Reference: Patrick Henry Library & Garage  
Project LB-000015, Fund 30030  
Project Update

The Building Design Branch (BDB) of the Fairfax County Department of Public Works and Environmental Services (DPWES) is pleased to provide the following project update for the redevelopment of the Patrick Henry Library and Garage.

### **3. BDB Staff Response to the Town Council's Questions:**

Figure 1. Land coverage needed for library program only, not for design intent.

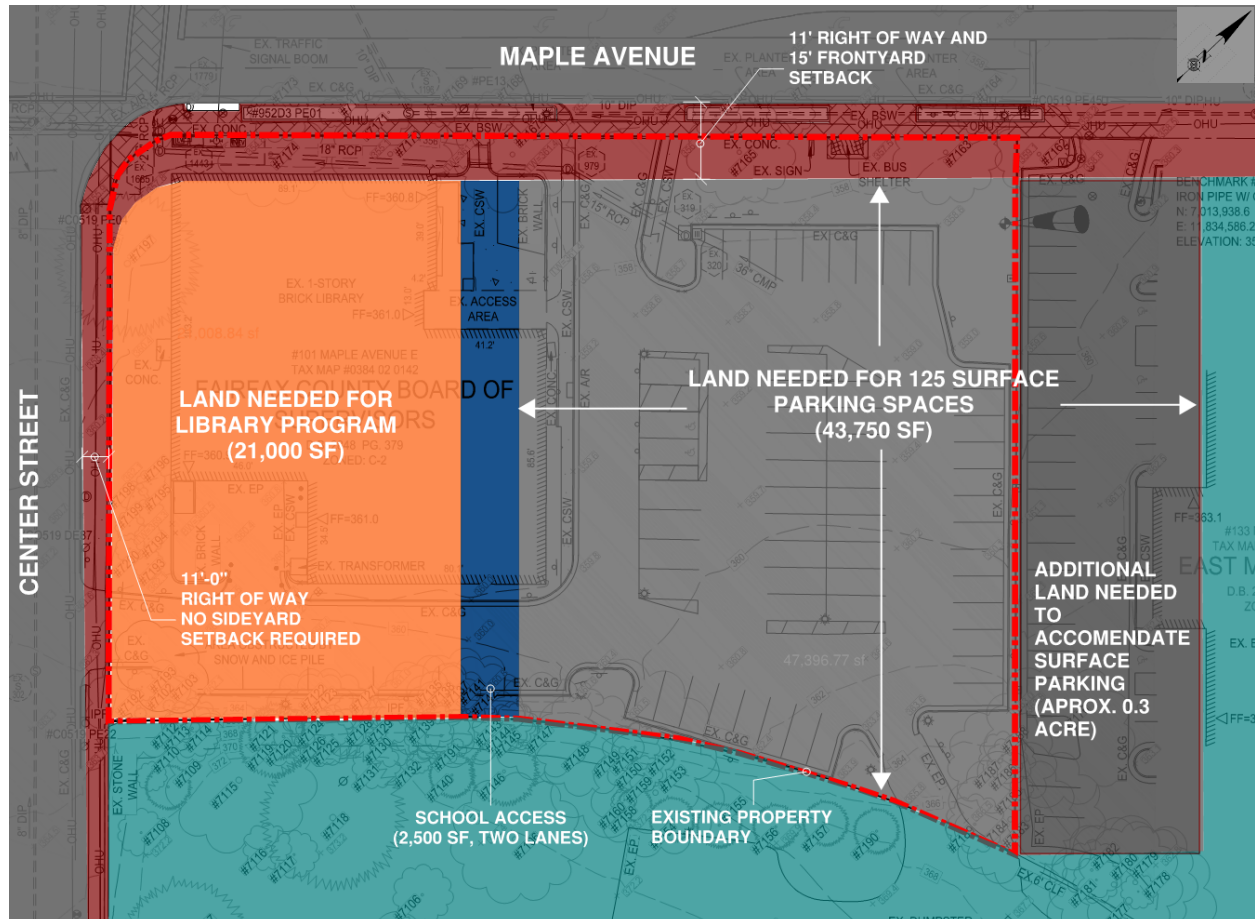
**Council Question 3:** The Town wants as much setback as possible from Maple Avenue to allow walkers and bikers to have access. One Council member mentioned a 40-foot

setback, but that is not in the current code. The current planned setback meets the current code of 26 feet. Could more be achieved?

**BDB Response:** The Town of Vienna Zoning Area for C-2 zone requires a 26-foot setback from Maple Avenue, consisting of a 11-foot right of way from the curb to the property line and a 15-foot setback from the property line to the building (refer to Figure 1). Although the proposed design meets the required 11-foot right of way, it will not meet the requirement for a full 15-foot setback from the property line and will require a waiver. BDB will work with zoning for further evaluation and adjustment.

A 40-foot setback from either Maple Avenue or property line would significantly reduce the buildable area and make both the library and/or garage layout infeasible.

BDB would also like to note that the proposed design provides a minimum 15-foot-wide sidewalk along Maple Avenue. In comparison, the current sidewalk is less than 5-foot wide.

*Figure 2. Option 1 Conceptual Massing Plan and Elevation (Center Street)*

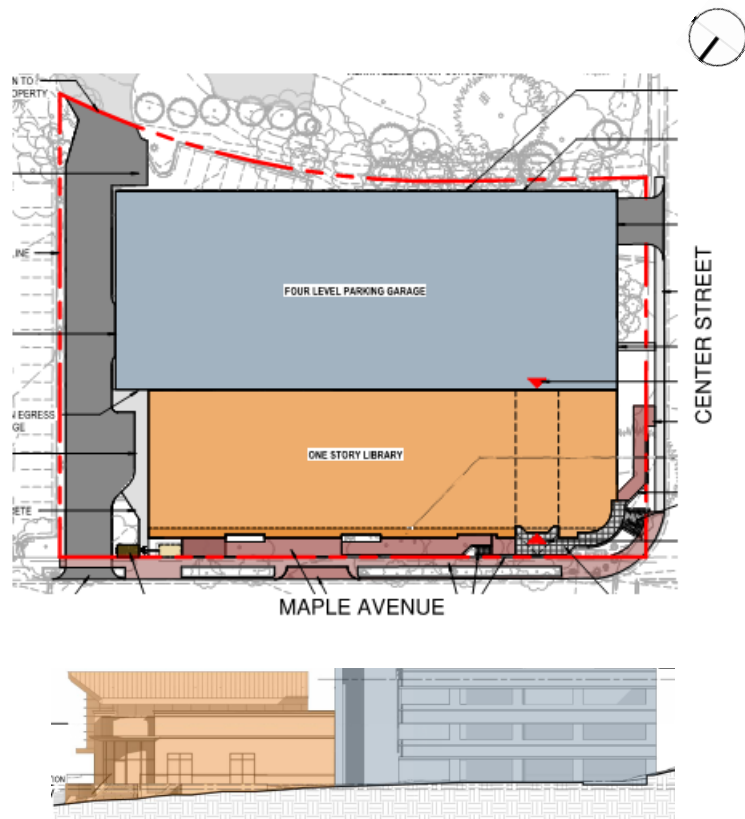
**Council Question 1:** The mass of the combined building and height of the garage was the overriding concern. Can a 2-story library / 3 or 4 level parking garage be designed?

**Council Question 2:** Can the parking garage be sunken a bit to reduce the height? Related - what is the cost increase to put one parking level below grade?

**Council Question 4:** Clearly define the garage entrance on Maple Avenue.

**Council Question 5:** How many spaces are on the top floor of the garage? If you were to eliminate that parking level, how many spaces would that eliminate, and how would that affect the cost?

**BDB Response:** The design of a 2-story library was evaluated by Library staff and leadership. In addition, the Town Zoning staff recommended that the County evaluate moving the library administration spaces to the second floor. After further assessment, BDB and the Library staff determined that locating library functions on two levels did not provide efficiency in their day-to-day operations, due to the need for additional staff, duplication of circulation desk, additional check-out kiosks, and additional supervision and oversight on two levels of the library. A 2-story design also requires stairs, elevators, and additional circulation space, which adds to the overall square footage and cost.

The garage floor to floor height is approximately 11 feet, which equates to a building height of 35 feet, comparable to a 3-story building with parking on the roof. However, based on the average grade and slope of the site, the garage exceeds the 35' height limit per zoning. As advised by the Town Zoning staff, a height waiver cannot be granted. BDB and the design team, with the guidance of the Town's Zoning staff, are currently working on alternative solutions to lower the building height, without compromising the programmatic and structural criteria, to meet the zoning requirements.

**BDB Response:** The design consultants are evaluating the possibility of lowering the first level of the garage while coordinating with the grade levels for vehicle access from Center Street.

The cost increase for one level of underground parking will result in 30% cost increase compared to the on-grade options. This is due to site excavation, waterproofing, and structural enhancements required to design an underground garage.

Additionally, the design team is exploring the possibility of reducing the overall garage height.

**BDB Response:** As the consultant team develops the concept and building facades further, the design of the garage entrance will be studied, and adequate wayfinding signage will be designed to better identify the entrance from Maple Avenue.

**BDB Response:** Removing the top level would also eliminate the need for the upper-level ramp which contains additional spaces. Removing the top level and the ramp would eliminate 66 parking spaces.

Eliminating 66 parking spaces would reduce the cost by approximately \$2.5 Million.
